Re: Toxic Substances Control Act, Polychlorinated Biphenyls (PCBs) – PCB Cleanup, Former Pechiney Cast Plate Facility, Vernon, California – AMEC's Proposed Modifications to USEPA's Approvals

In this letter, USEPA is modifying certain conditions in its PCB cleanup approvals under 40 CFR 761.61(c) dated July 2, 2010 (Approval #1) and July 1, 2011 (Approval #2). The modifications to these approvals are based on the above meeting, AMEC's January 24, 2014 e-mail message (attached)[1], the Approvals. These modifications are been made consistent with the requirements in 40 CFR 761.61(c).

From: Conlan, Linda [Linda.Conlan@amec.com]
Sent: Friday, January 24, 2014 12:32 PM
To: Santos, Carmen
Cc: Gerald Pepper (gerald.pepper@gmail.com); Hardcastle, Calvin
Subject: PCBs - Pechiney - Proposed Changes to the Conditional Approvals
Attachments: Pechiney_Soil Removal Area 5a_5b_5c.pdf

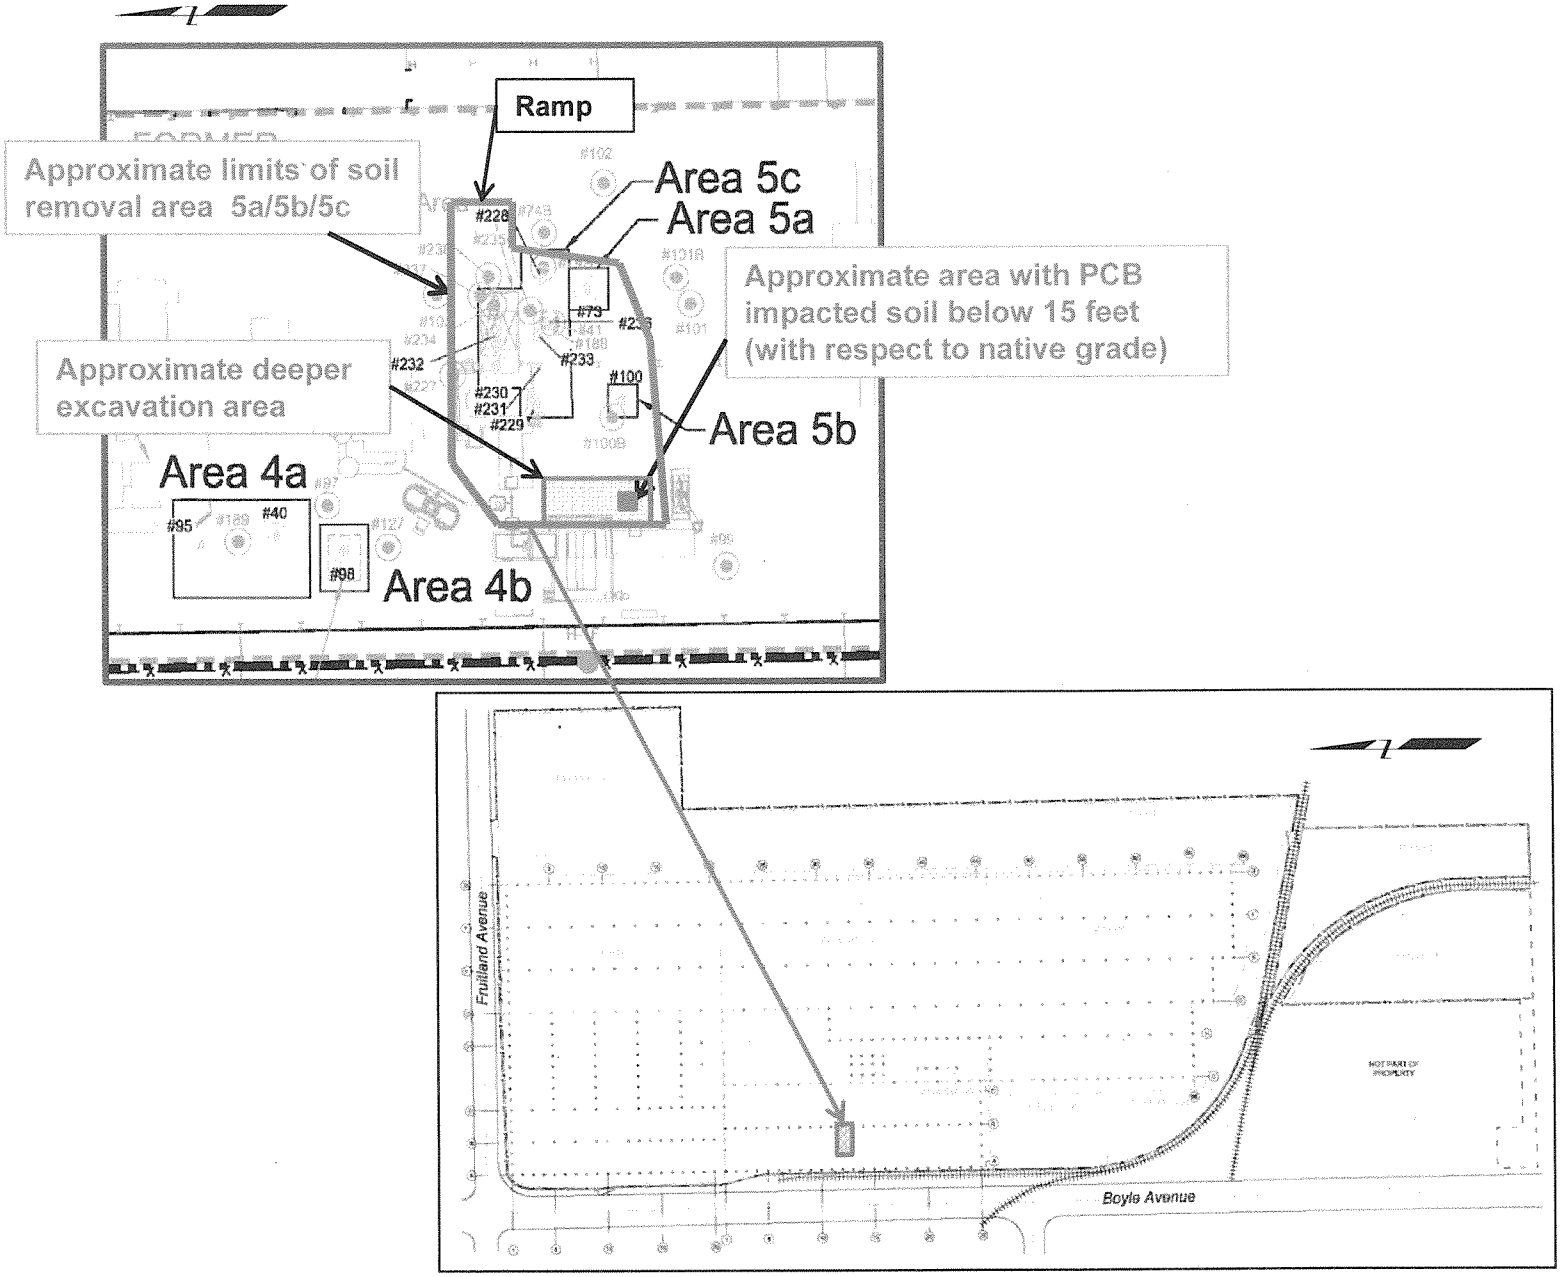
3) **PCB impacted soil at depths below 15 feet.** PCB-impacted soil at depths greater than 15 feet (below native grade) has been encountered in the soil removal area 5a/5b/5c areas (also referred to the Area C in our Application and the 2012 RAP). In this area, the existing concrete slab is about 4 feet above native site grade. The base of the deeper portion of the soil removal area (shown in blue on the attached figure) is currently at about 21 to 30 feet below the slab (or about 17 to 26 feet below native grade) depending on the location on the excavation floor. In the southern portion of the deeper excavation, soil containing PCBs at concentrations exceeding 23 mg/kg (actual measured concentration at this location is 73.6 mg/kg) is proposed to be left in place at an approximate depth of 26 feet below native grade. These site conditions are similar to the site conditions as specified in the Conditional Approval (refer to Section C.3.b.6; July 2, 2010 Conditional Approval letter and site grading plan) for the proposed 4a/4b soil removal area.

The proposed modification to the Approval includes placing a physical barrier consisting of a minimum of 6 inches of concrete or cement slurry over the PCB-impacted soil at depth of greater than 15 feet below native grade. This modification will be applied to any areas where soil containing PCBs at concentrations greater than 23 mg/kg at depths greater than 15 feet below native grade with conditions consistent with the Approval for the proposed 4a/4b soil removal area. At this time, this modification is only expected to be applied to the 5a/5b/5c (Area C) excavation. For Area C, a cement-slurry in lieu of the concrete may be used based on worker safety

USEPA Modification to Approvals #1 and #2. The total PCB and Aroclor 1254 concentration in soils below 15 feet below ground surface (bgs [i.e., below native grade]) must be confirmed via collection and analysis of in-situ, discrete samples during underground demolition, if such data does not exist already. Soils below 15 feet bgs are defined here as Deep Soils.

Alternative: Deep Soils (below 15 feet bgs) exceeding 23 mg/kg total PCBs and/or 2.0 mg/kg Aroclor 1254 (where Aroclor 1254 is the only detected Aroclor) before or after soil excavation and removal, may remain in place if:

(b) A physical underground warning barrier (UWB) that is effective for the long term is installed at the floor of the 5 to 15 feet bgs PCB-remediation interval for soils. The UWB will warn about the presence of Deep Soils beneath the UWB exceeding the cleanup levels for the 5 to 15 feet bgs remediation interval.

The UWB shall be constructed with concrete or cement slurry or other suitable material that allows a completion thickness of 6 inches for the UWB. The UWB shall be overlain by a colored (e.g., orange) mesh geotextile layer.
